37/3-98W 7611 Takoma Avenue
(Takoma Park Historic District)

PROPOSED ALTERATIONS & ADDITIONS TO: ARONSON RESIDENCE. 7611 Takoma Avenue, Takoma Park, MD 20912

PROPOSAL: Delete garage, build open pool pavilion,
revise parking, revise kitchen entrance

Address: 7611 Takoma Avenue Meeting Date: 9/9/98
Resource: Takoma Park Historic District Review: HAWP
Case Number: 37/3-98W REVISION Tax Credit: No
Public Notice: 8/26/98 Report Date: 9/2/98
Applicant: Mr. Bernard Aronson Staff: Robin D. Ziek
PROPOSAL: Delete garage, build open pool pavilion, RECOMMENDATIONS: APPROVAL
revise parking, revise kitchen entrance w/CONDITIONS

PROPOSED SITE PLAN
 SCALE: 1/8" = 1'-0"

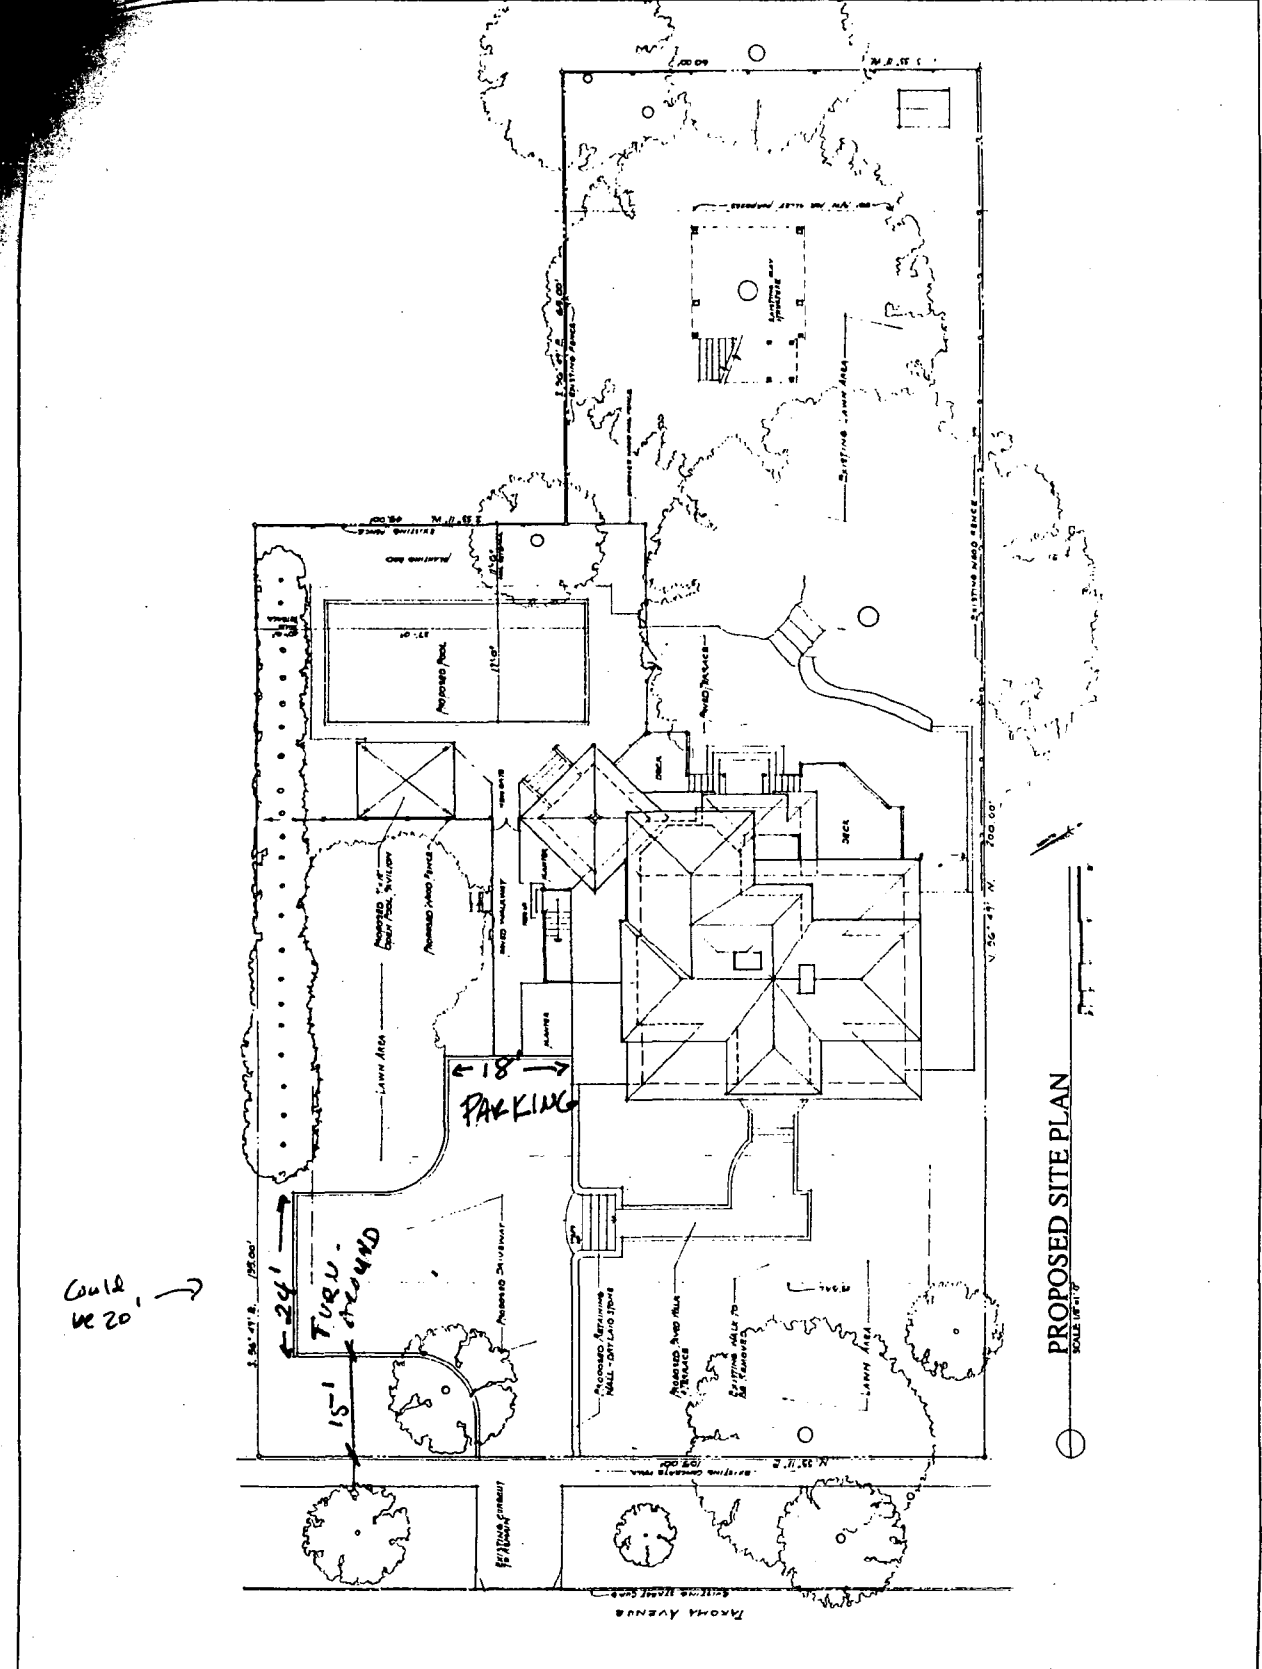
Could
 be 20' →

SITE PLAN REVISED 9.02.96

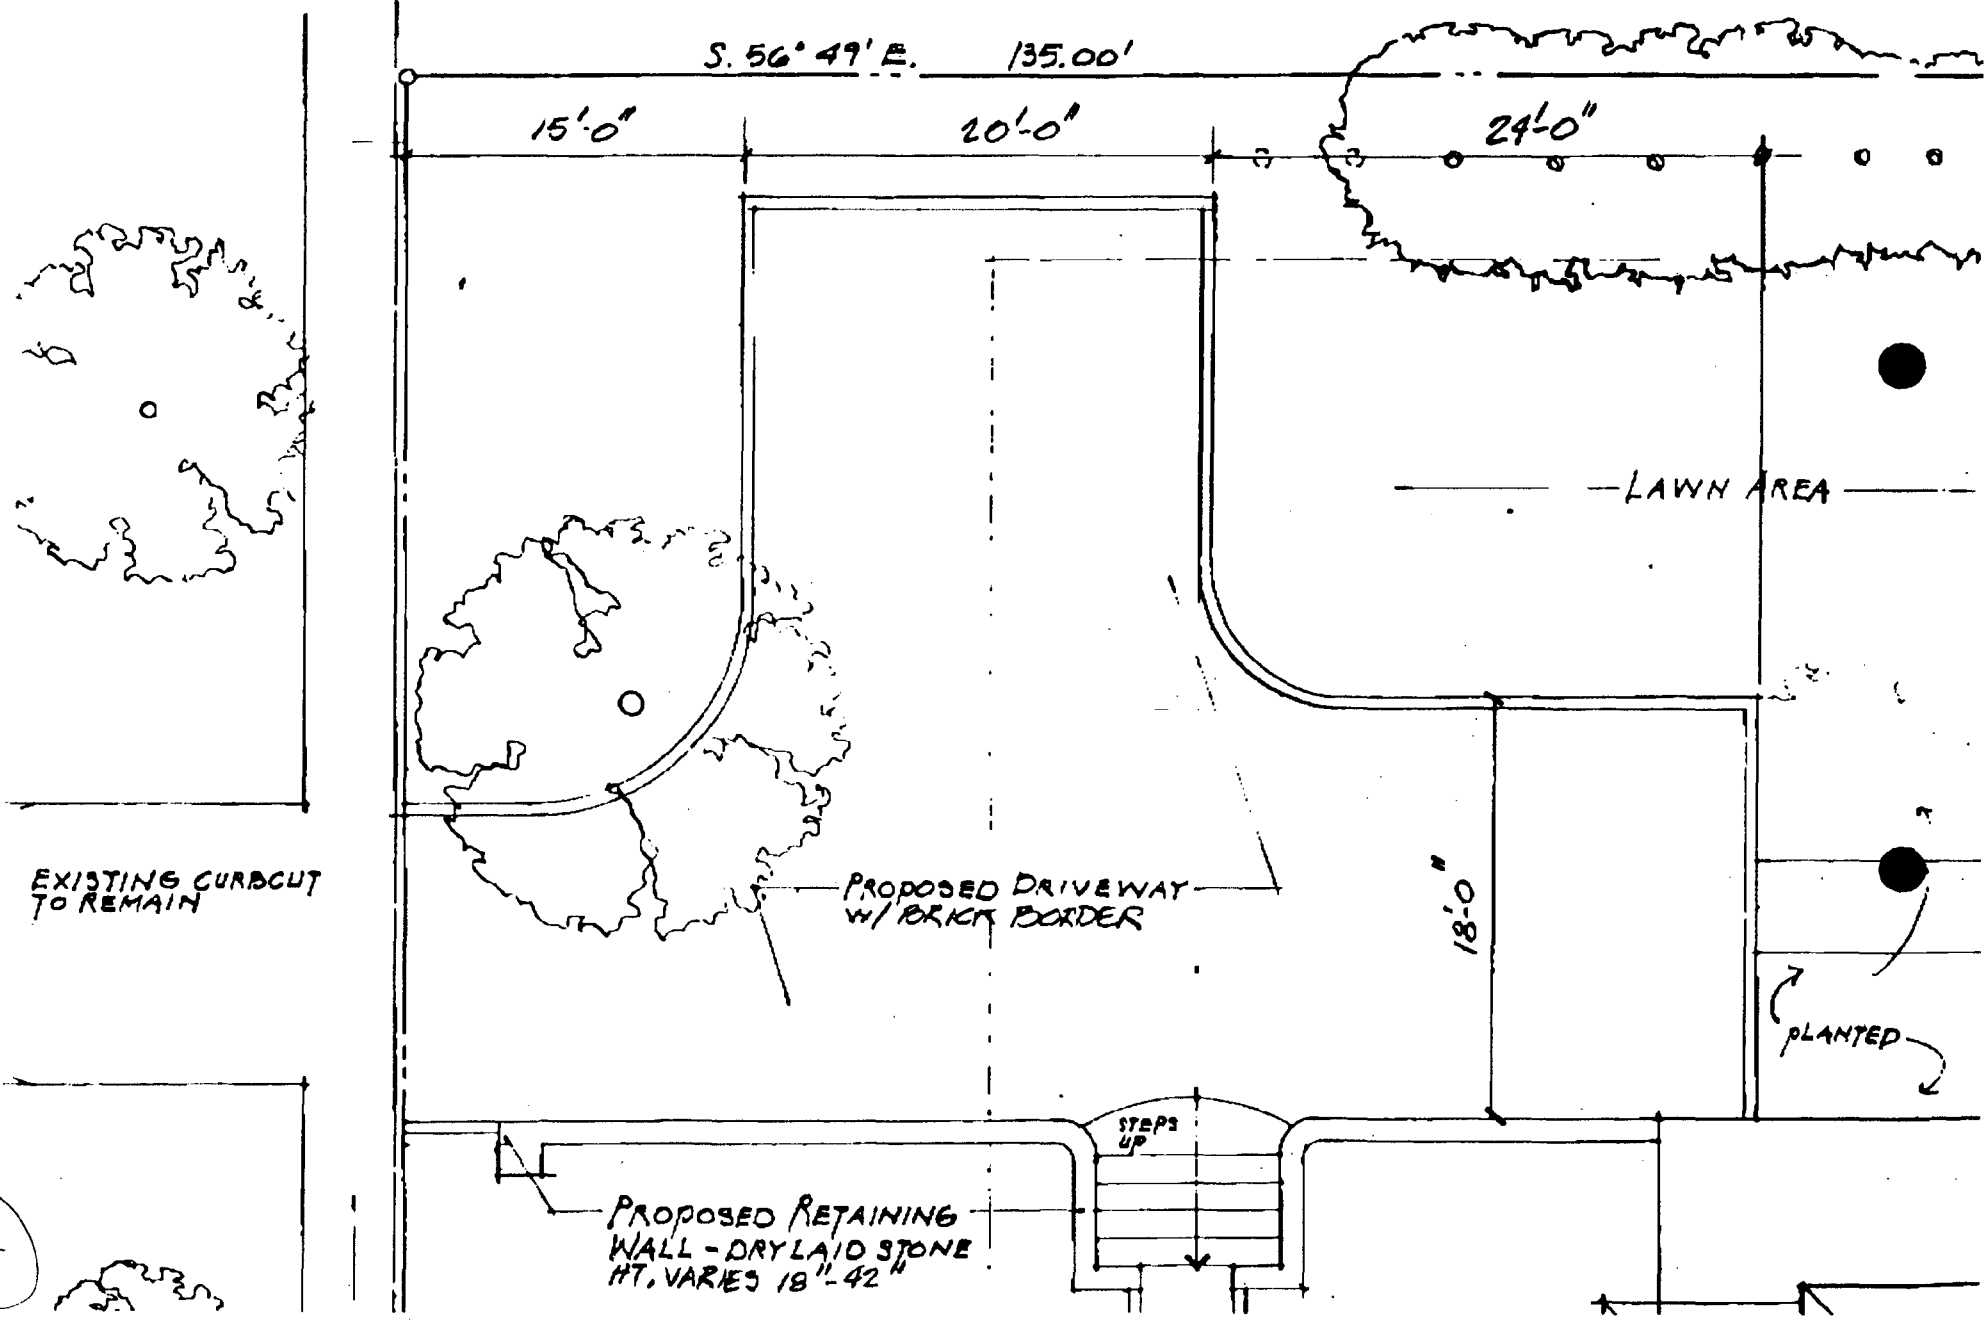
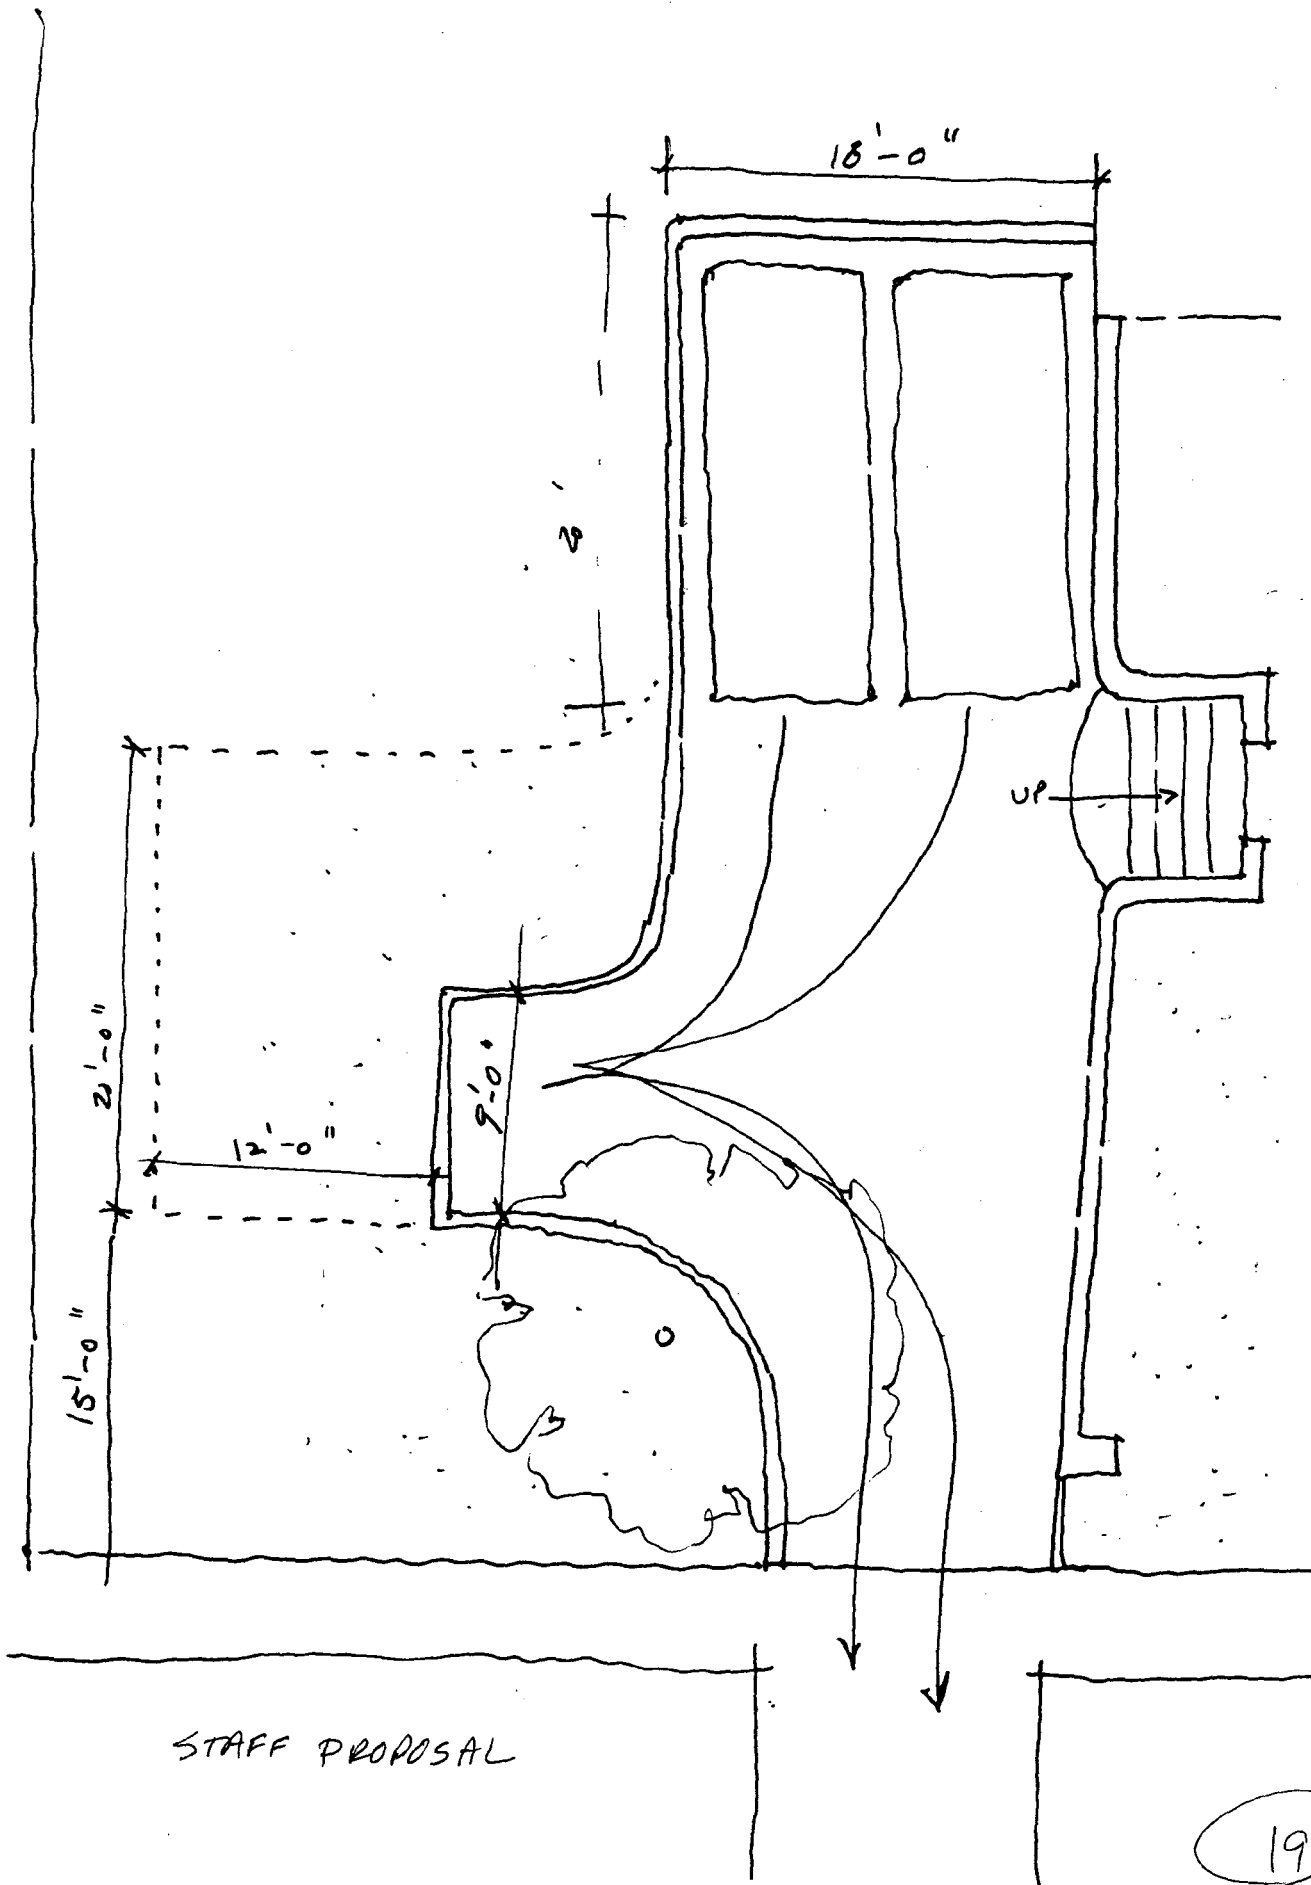
A. Amount of paving in front yard to be cut from 24' to 20' in width. I have enclosed a partial paving plan to show reduced width to 20 for you files. The double line around parking and turn around areas only indicate a brick or cobble border to contain the future paving material, whether asphalt, concrete, etc. It is not a retaining wall.

C. Stone retaining wall will stop several feet short of the walk along right side of driveway as modified on the new plan.

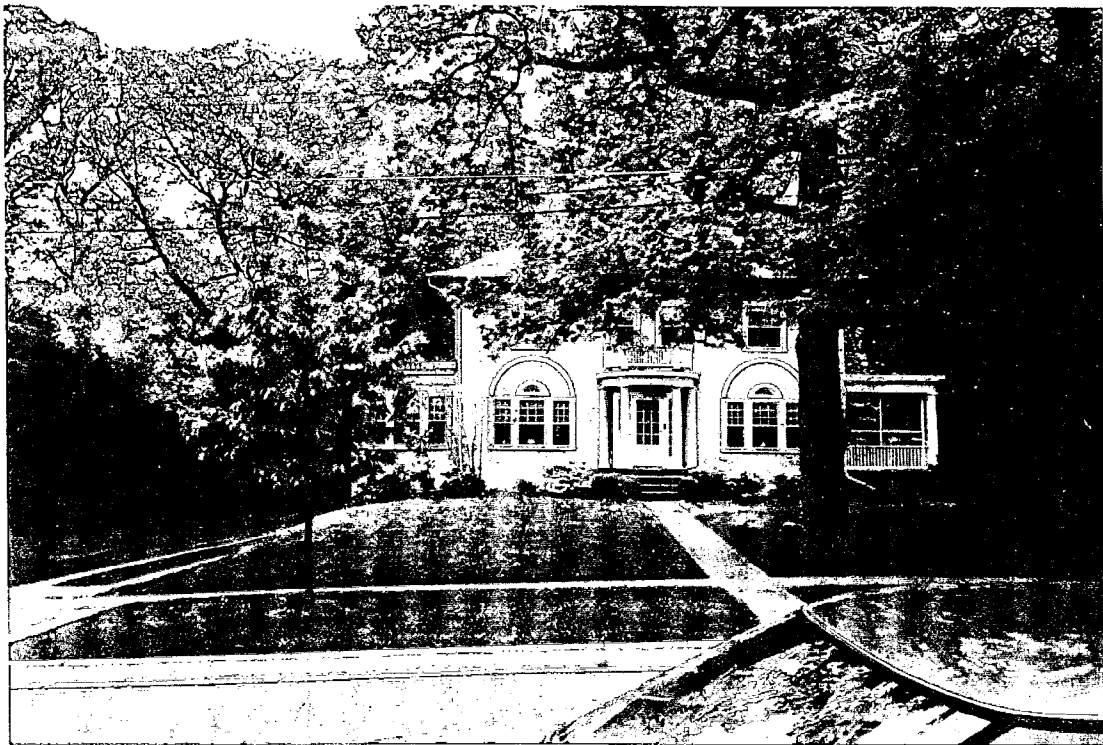
Drop blind arceding at ~~garage~~
closet

4. Minimize driveway entry piece
at sidewalk connection

5. Drop berm. Keep front walk
